**ADDENDUM  
NO. 03**

**May 22, 2026**

**Kalamazoo Public Schools EL SOL School  
1428 Baker Drive  
Kalamazoo, MI 49048**

This Addendum consists of Pages ADD 3-1 through ADD 3-3 and TowerPinkster Addendum No. 03, dated May 21, 2026, consisting of 5 pages, additional Specification Section 07 21 00 Thermal Insulation, and 20 drawings.

SHEET NUMBER  
**E 201B**  
23-622.000

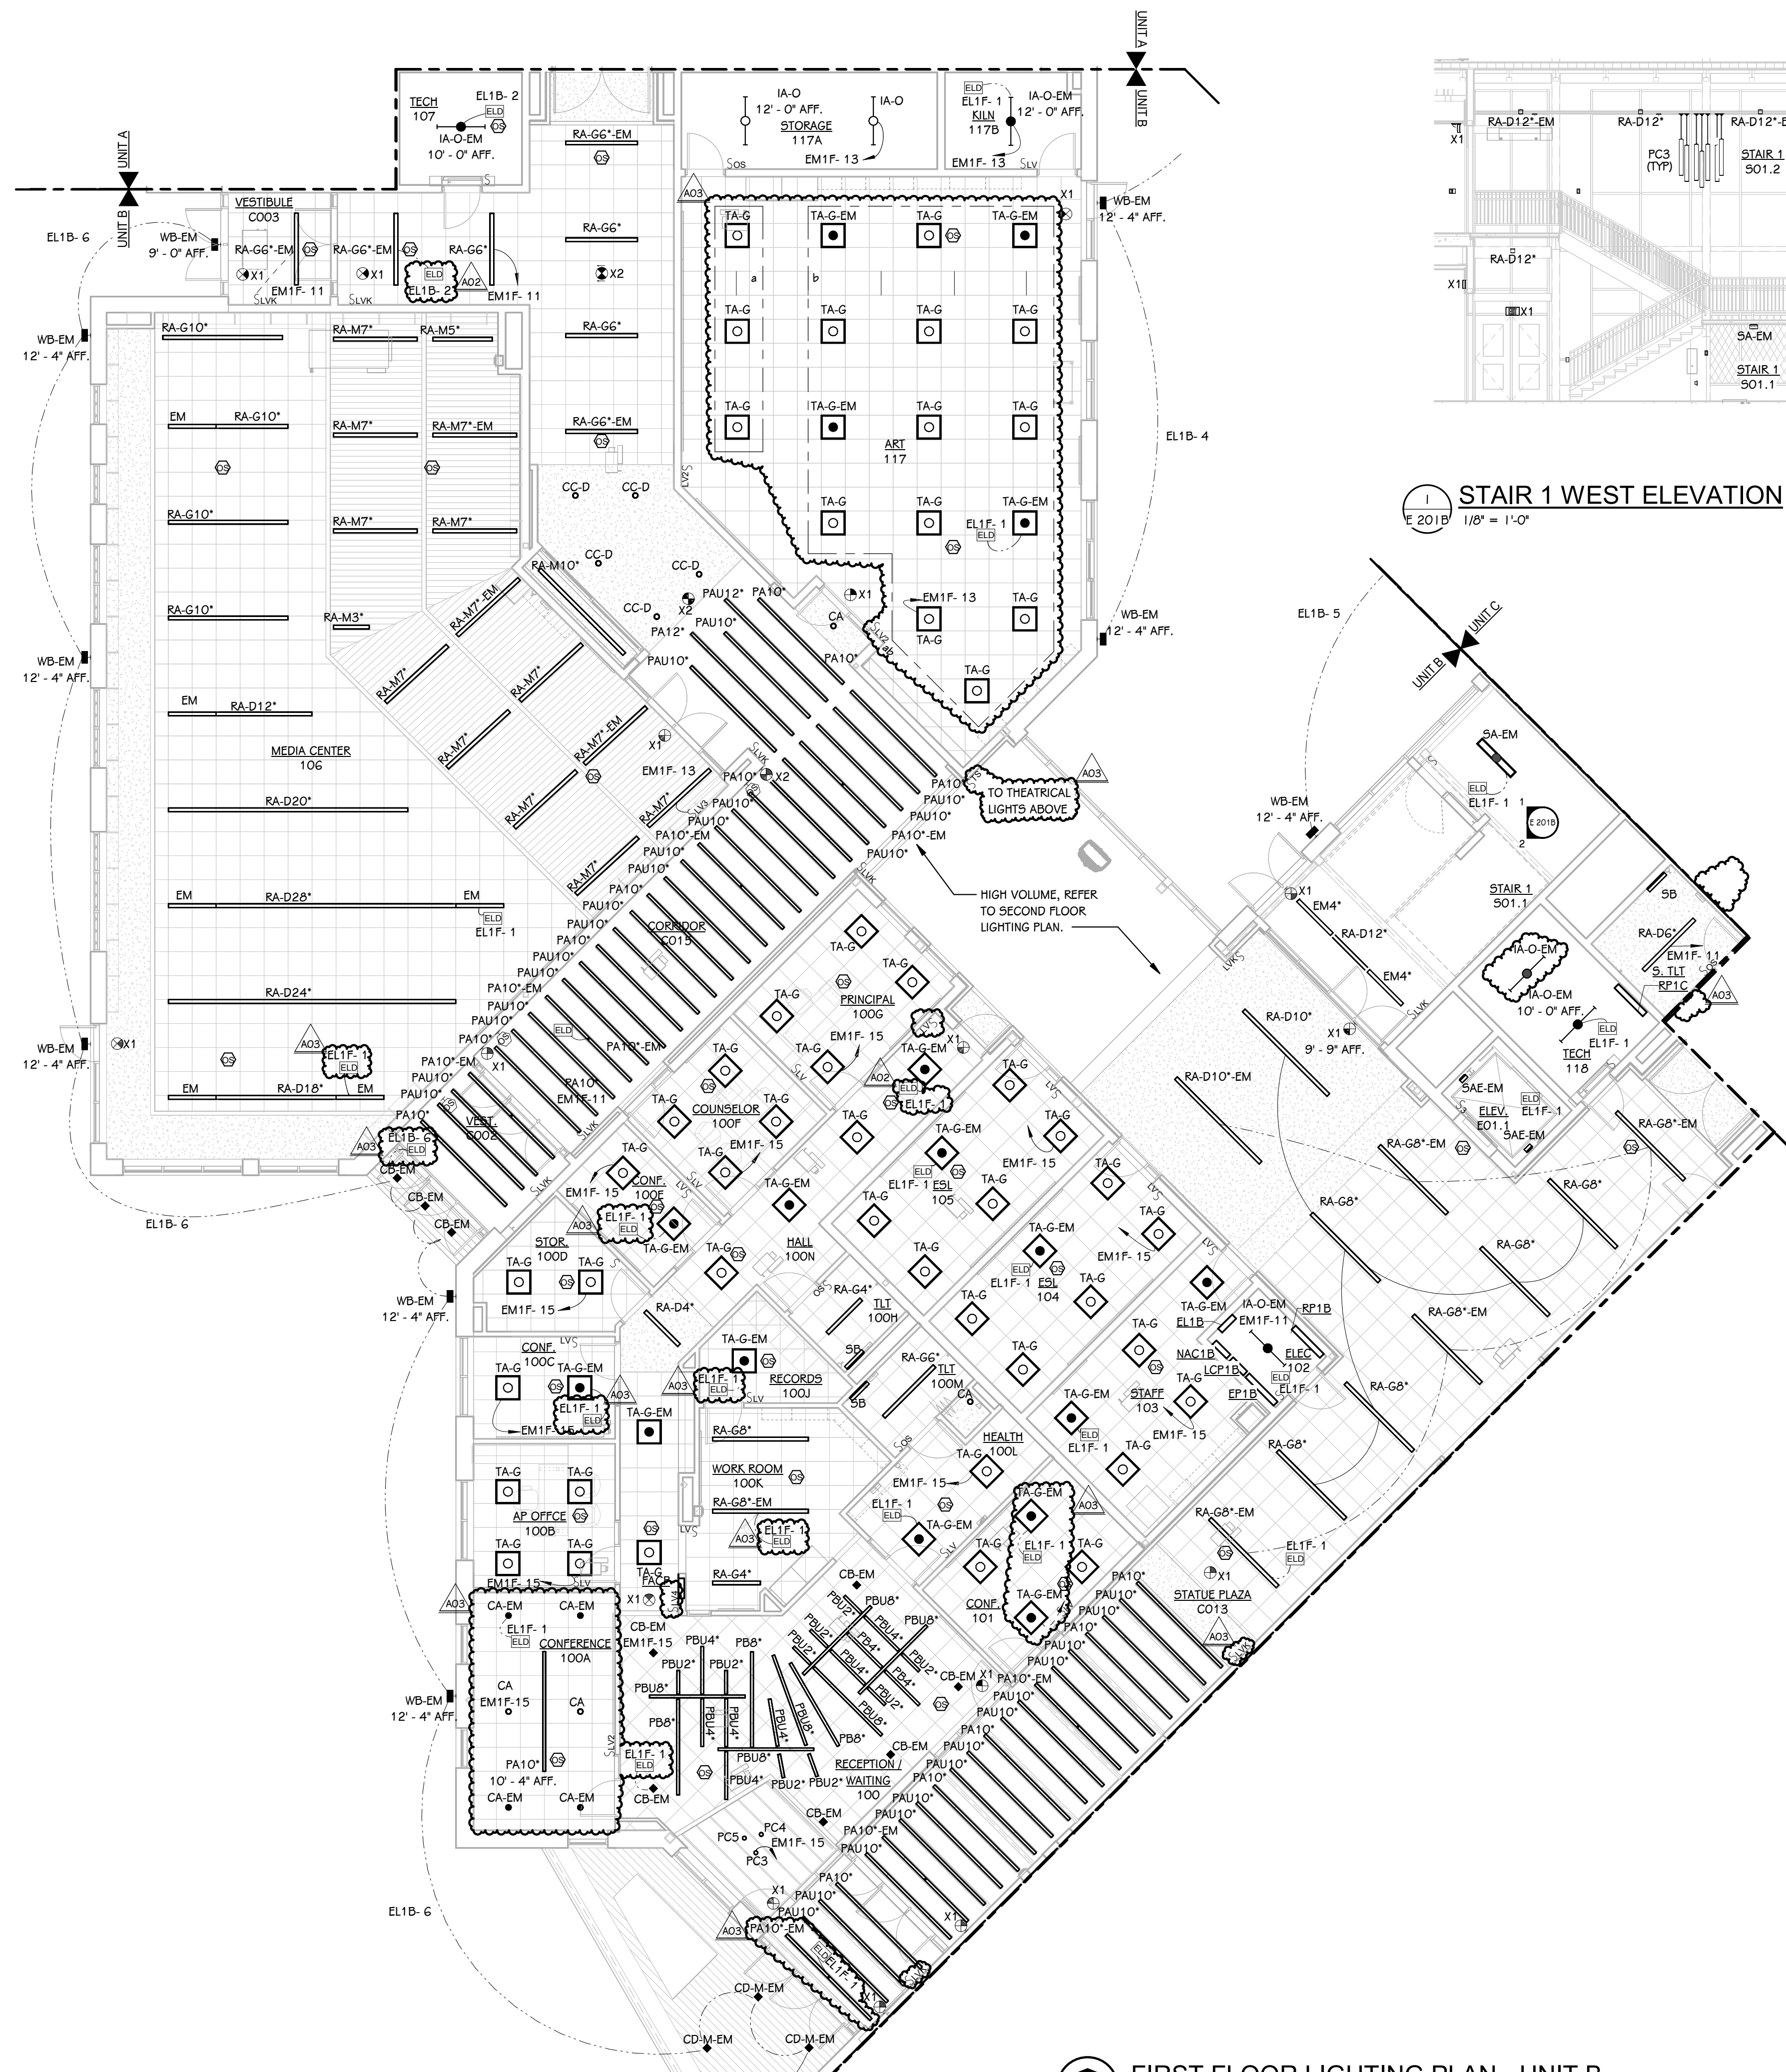
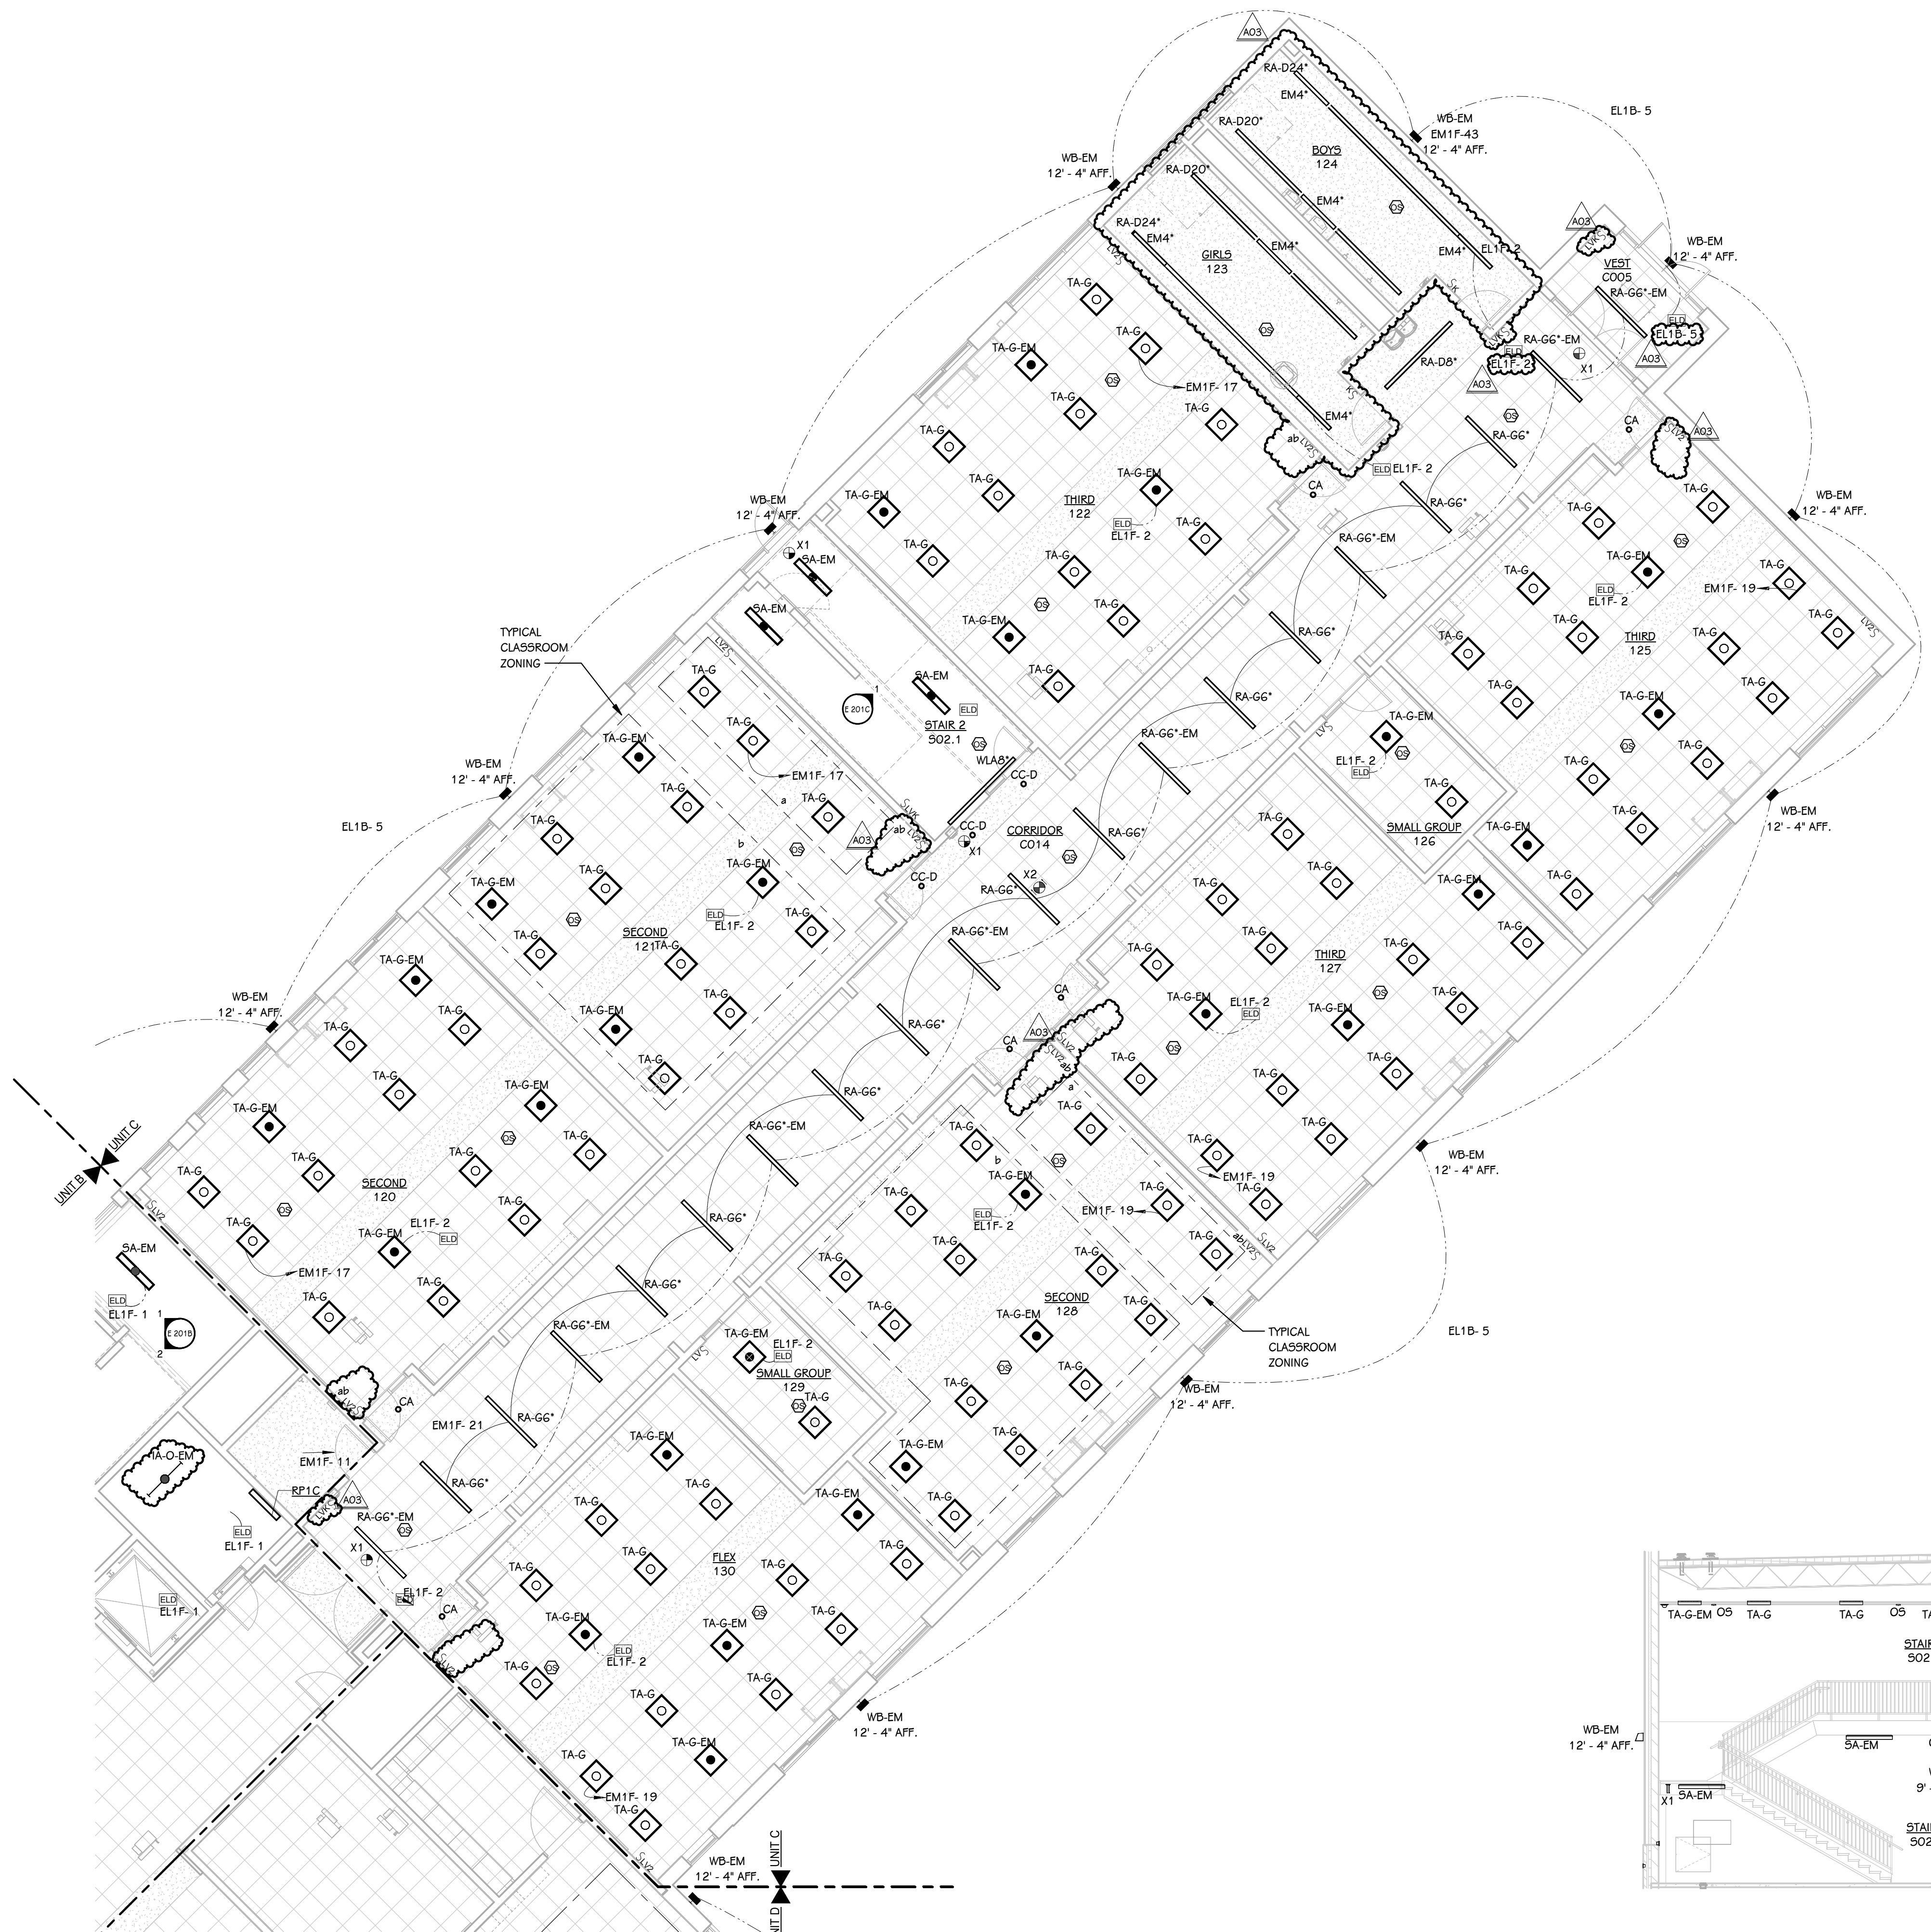
Added additional ELD lighting devices and associated emergency lighting circuits throughout the building.

Added additional switches and revised switch type throughout the building.

Revised lighting types in meeting room 109D and 100A. Revised switch to 2 zone.

Added touch screen to statue plaza and lighting keynote #2. Revised track fixture to theatrical lighting fixture.

Added lines to indicate zoning. Revised EM lighting locations and associated ELDs.

SHEET TITLE  
**FIRST FLOOR LIGHTING PLAN - UNIT C**

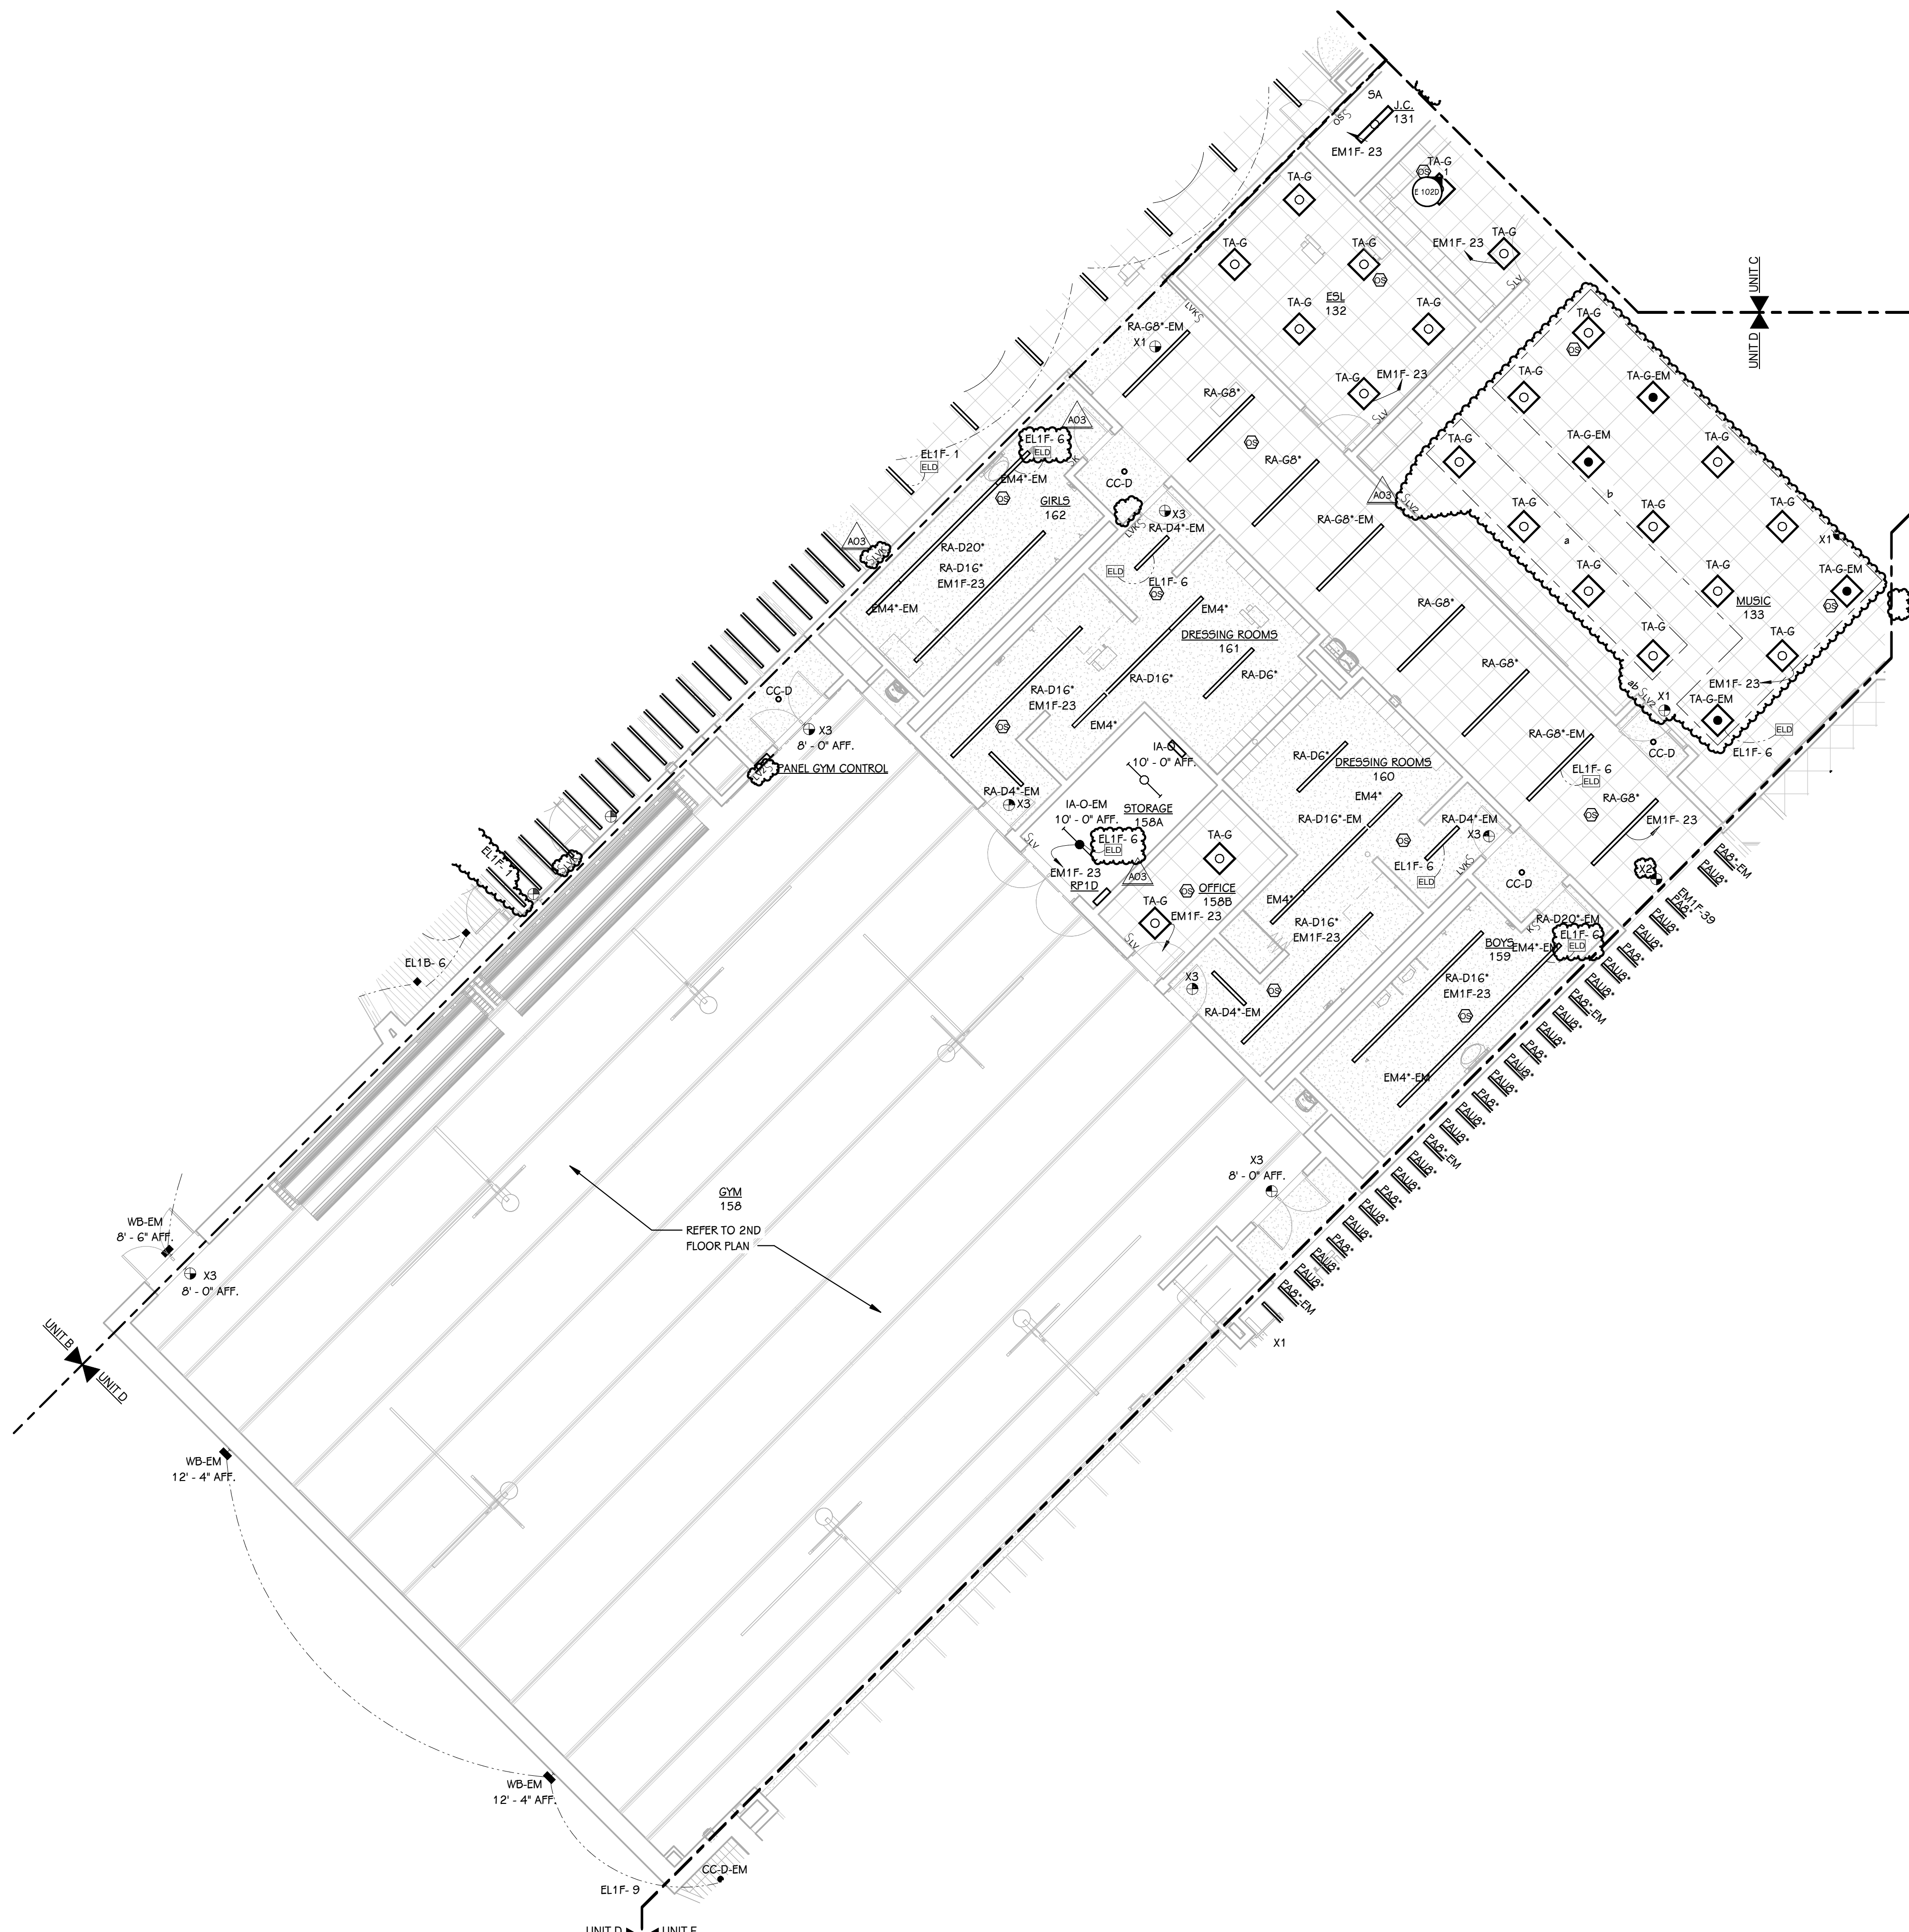
Remove unnecessary exit signs from classrooms in unit C.
